21-140ARB-INF – 94 FRANKLIN STREET – CRONE RESIDENCE

21-140ARB-INF
Informal Review
94 Franklin Street

1) West Elevation – Franklin Street

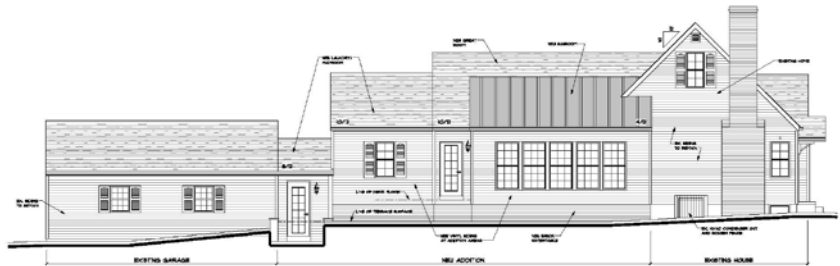
new sunroom addition in the northernmost portion of the addition, extending 11 feet from the face of the existing home. The footprint of the addition will also extend up to 6 feet from the face of the existing home to the south. The elevation provides a mix of front and side-facing gables with multiple different slopes, as well as a shed dormer roof above the sunroom. The applicant is proposing new white horizontal vinyl siding as the primary cladding material of the addition, matching the existing home. A burgundy thin brick watertable is carried along the foundation of the new addition. The majority of the addition will be sheathed in asphalt shingles. Additionally, the applicant is proposing to remove the two black awnings on the existing home windows, and propose new and replacement 4-over-4 and 6-over-6 vinyl

windows without trim. The southernmost window is proposed to have new shutters. The use of vinyl siding and windows is not permitted in the Historic District Zoning Code. Should the application move forward to a Minor Project Review, the applicant would be required to obtain a Waiver for the use of vinyl materials.

Preservation Designs recommended that the new addition should not be visible from the front of the building since it will detract from the historic character of the Minimal Traditional home. Additionally, the consultant recommends that materials for additions should be consistent with those in the original structure and complementary to the district. The original siding for the home was wood siding, not vinyl, and the original windows were likely wood sash windows with simple trim. The *Historic Design Guidelines* recommends that replacement windows should duplicate the appearance of the originals as closely as possible in the number of panes and materials.

3) *South Elevation – Side Yard*

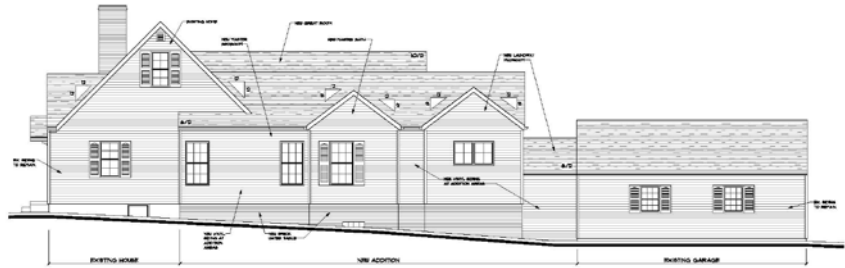
The south elevation contains a number of different rooflines, including the side gable of the existing home, the multiple front gables of the addition and garage, and the side-gabled dormers of the addition. The proposed addition will require the removal of one existing window opening on the south elevation, as the applicant will remove a portion of the southeast corner of the exterior wall to fit with the proposed floorplan of the home. The addition extends towards the detached garage, where a proposed hyphen between the addition and the garage will create an attached garage. The south elevation will be clad in horizontal siding and a thin brick watertable, with a variety of different window sizes and pane selections. The addition will be sheathed in asphalt shingles.

Preservation Designs recommended that the original window opening be preserved, similar to the north elevation. Additionally, the consultant recommended that the multiple rooflines of the addition need to be simplified to maintain the Minimal Traditional form of the building.
